Block 5 - The Bottling Plant

Block 5 - The Bottling Plant

Block 6 - Hotel

Submitted proposed alterations to existing south elevation

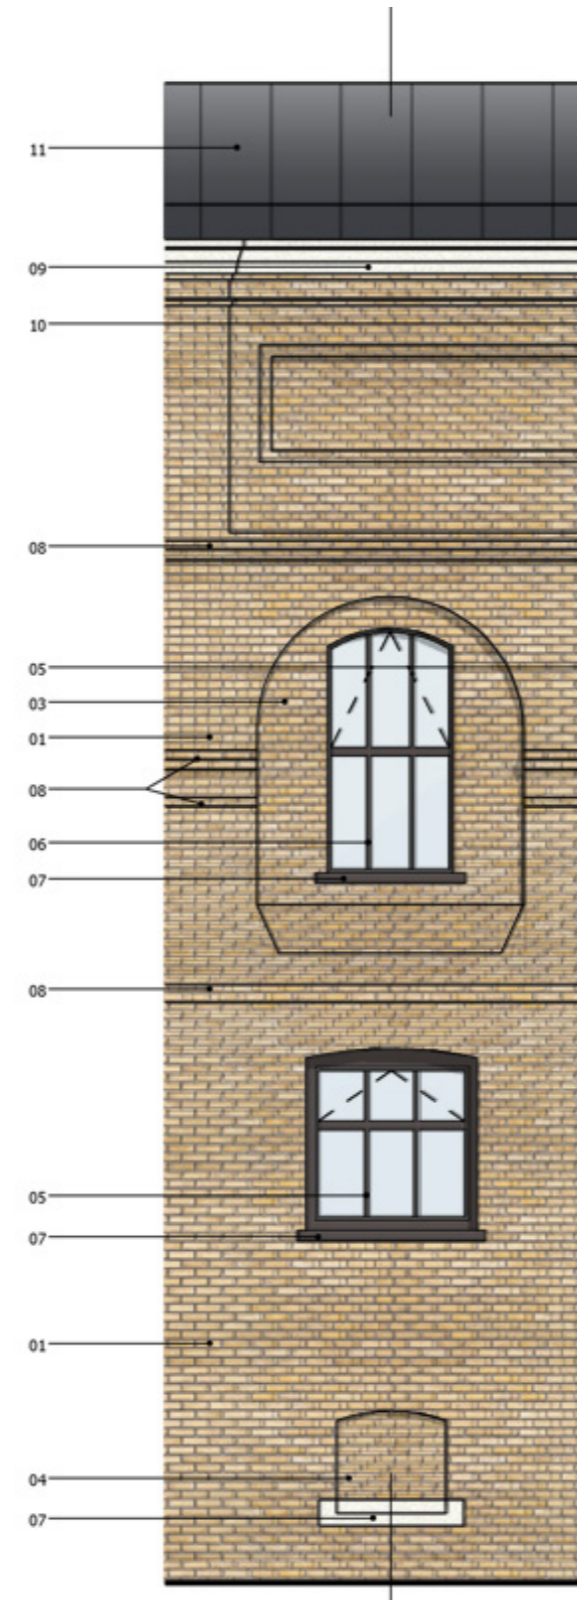
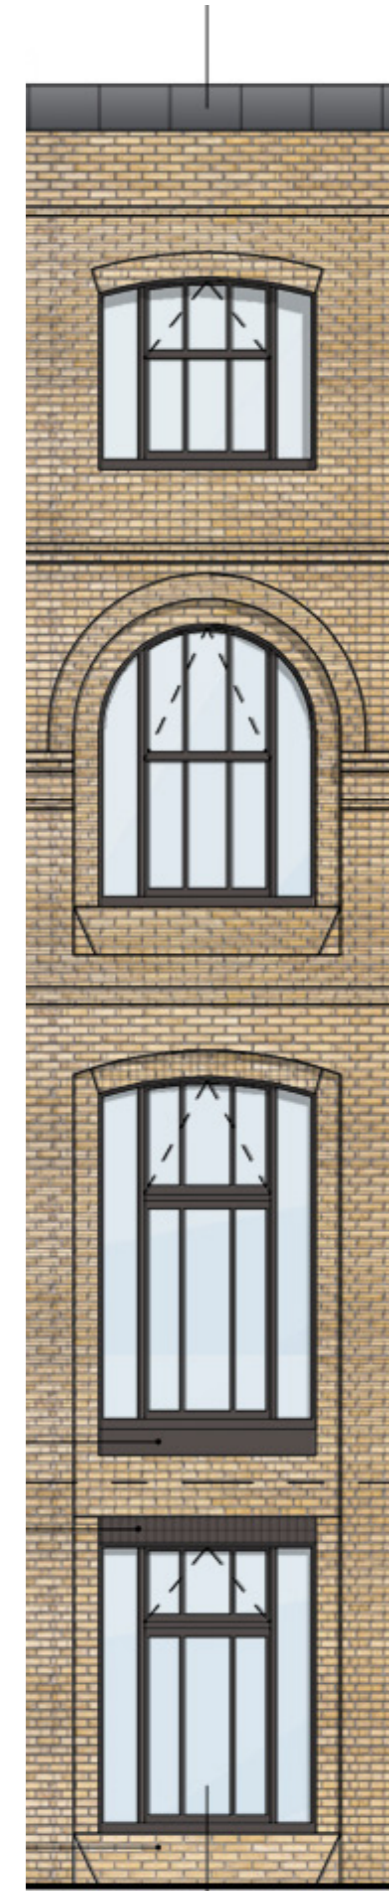
2. Front/ south elevation: Was the fenestration inserted on the High Street elevation based on historical information? It is not clear as to whether fenestration designs are copies of originals; this needs confirmation. Provide details of fenestration choice.

The fenestration designs for the proposed altered south elevation are copies of the existing timber casement windows. It is proposed that all new windows will be double glazed timber casement windows.

The fenestration in the new areas of façade to the north (facing the new 'High Street/ Thames Street') and east are proposed as contemporary interpretations (as opposed to direct copies) of the existing arched window openings on the retained south elevation.

The diameter of the existing arched openings has been utilised to form the outermost opening of the new second floor level window reveals. That shape has been offset in stepping brick reveals.

A hierarchy is also proposed to these window openings, with the re-interpreted arch positioned at second floor level (same level as on the retained façade) and a paired set of windows with a stepped flattened arch reveal below and a squatter flattened arch window at the top of the building.

Revised bay study elevation of bottling building facade - to be re-submitted

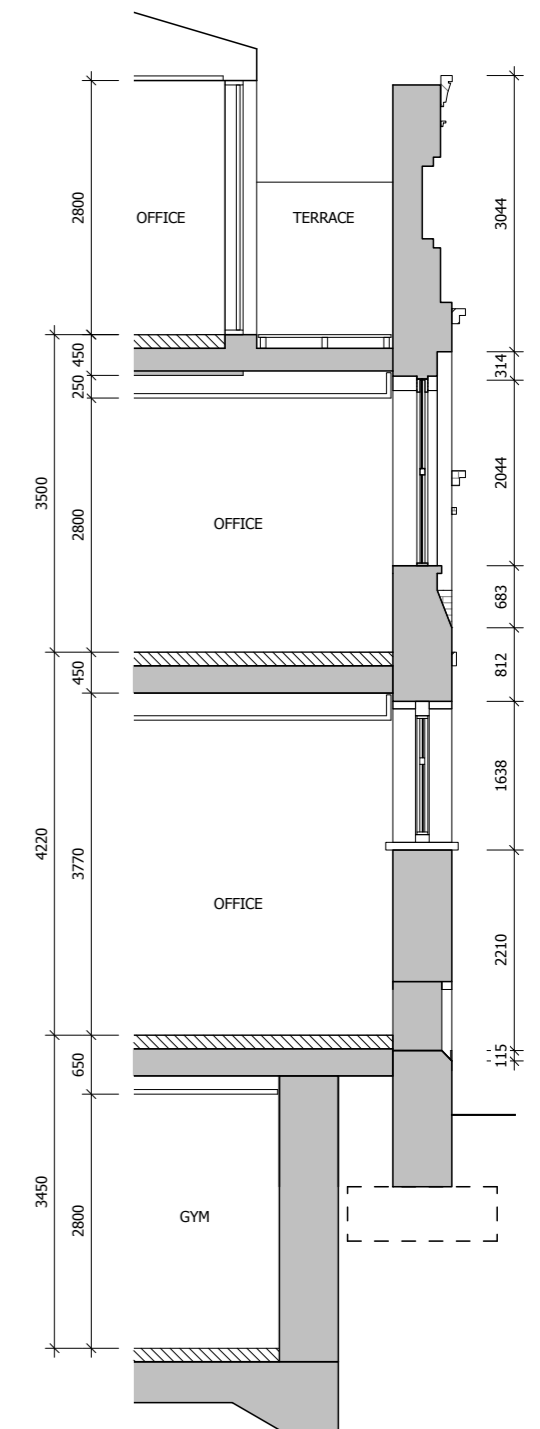
- The significance of the south façade is the orchestration of the recessed bays with the gauged arches to windows set within the gauged arches to the bays. This detail is not shown on the application drawings. The two timber access doors to what would have been a hoist have been infilled with brick on the proposed plan, which is the same treatment as the one to the east, albeit already carried out. The drawing of the one to the east lacks the lintel above what was the pair of timber doors in the drawing, although it is still present on the building. There is a case for infilling the opening with timber to give a historic interpretation of the function, albeit to insert windows. If the scheme is retaining the existing south façade as it is apart from the inserted windows (which it should) then there is less than significant harm to the main public elevation, but the drawing should show the details of the gauged arches as there is a suggestion the south façade is being replaced. South elevation: correct drawings to show retention of lintels and brick detailing. Amend to reflect comments.

The submitted drawings do not propose the demolition of the south elevation of the bottling plant. Furthermore, the brickwork detailing to the heads of existing openings is proposed to be retained as existing.

The proposed fenestration to the existing (and altered) window openings has been based on the design of the existing fenestration at first floor level of the building. These windows incorporate two mullions (three panes of glass) and one transom each. Likewise, the design of windows at second floor level (which are less squat in terms of proportion) are new interpretations of the existing windows. It is proposed that the new first floor windows will be double glazed timber casement windows and that the second floor windows will be polyester powder coated metal. Drawings have been adjusted to show a timber infill instead of brick infill to the former hoist door.

The existing openings at ground floor level are semi-basement level windows. The proposal for the conversion of this building intends to provide level access to the new 'Bottleworks Square' on the opposite side of the building. The levels that have been established to achieve this relationship unfortunately mean that retention of these windows is not possible. These openings (which are currently boarded up and serving a semi-basement level) are proposed to be bricked up.

For clarity, drawings have been revised to show the fine detailing of the existing brickwork. We would also be happy to revise the drawings to infill the former hoist door openings

Revised east elevation of Hotel

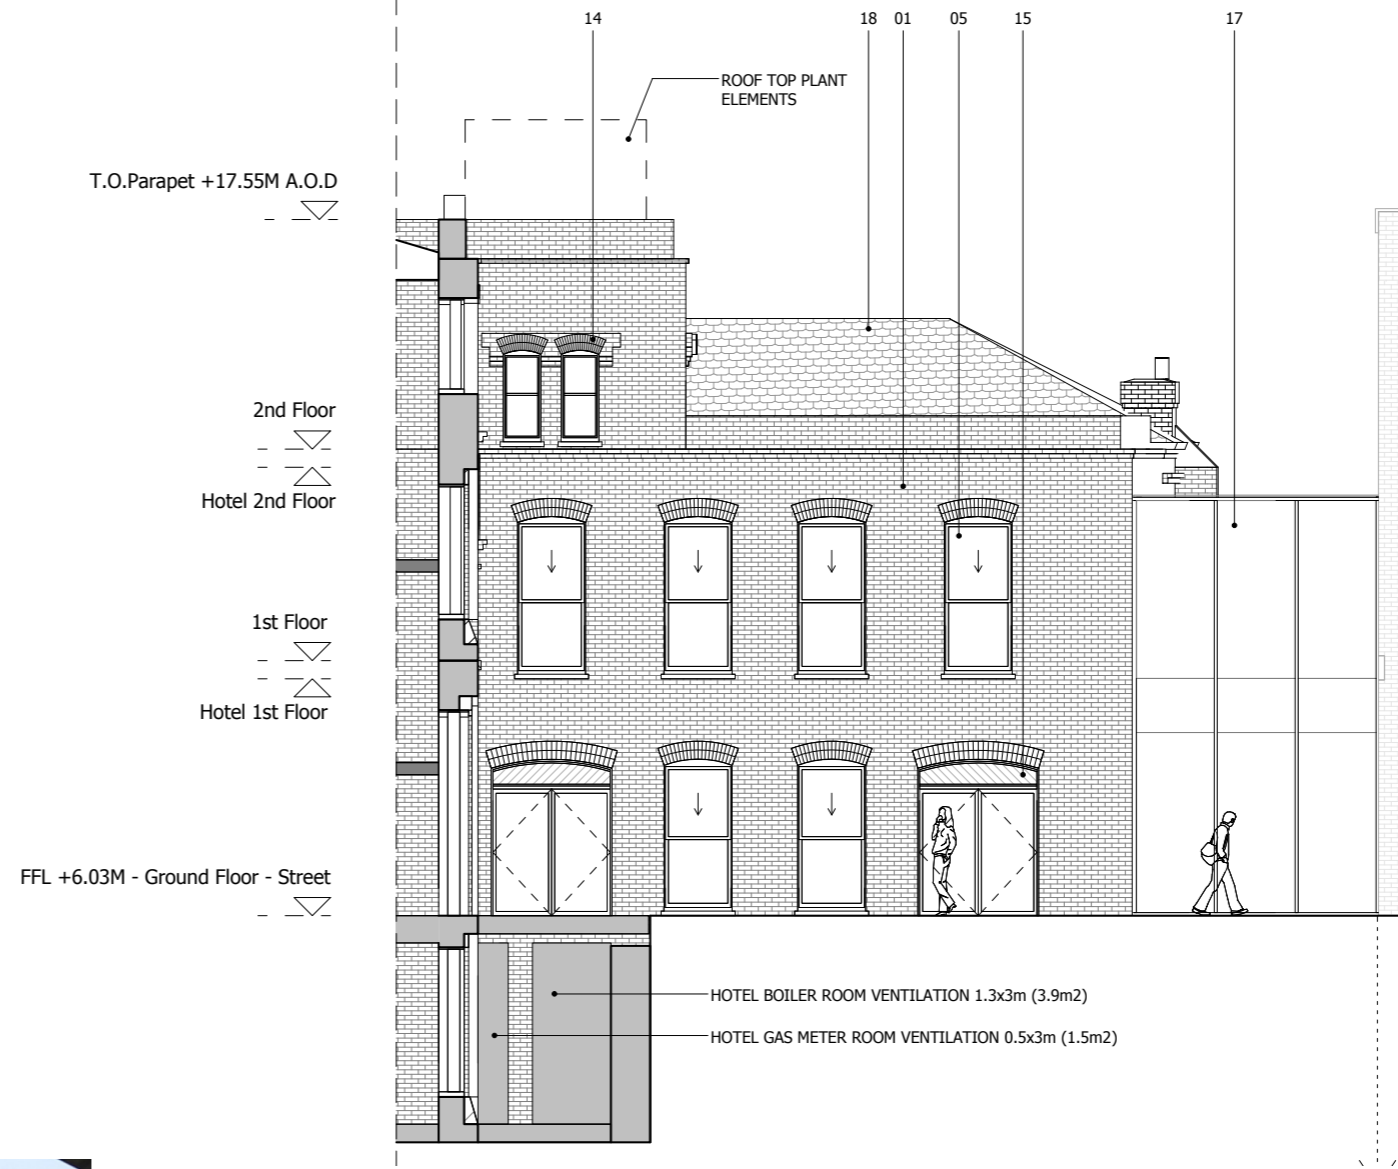
1. North façade of hotel – This building is a BTM in a prominent position. Facades are clearly visible from the public realm and the building forms an important part of the character of this part of the conservation area. The loss of all but the west/south façade represents substantial demolition and harm to BTM with lack of justification. Provide justification for substantial demolition. Must retain front and side facades, the roofline and chimney stacks.

We disagree that the North façade should be retained as opposed to demolished. The existing North façade meets an existing ground level which sits 810mm lower than the proposed new 'Bottleworks Square'. This new level is required due to flood level constraints (the level has been established in order to provide accessible routes that mediate between the existing streetscape and highest levels of flood defence). It is also proposed that a new (deepened) basement level is provided beneath the existing hotel. The combination of these factors make it an unviable solution to retain the north façade as part of the proposal for the hotel.
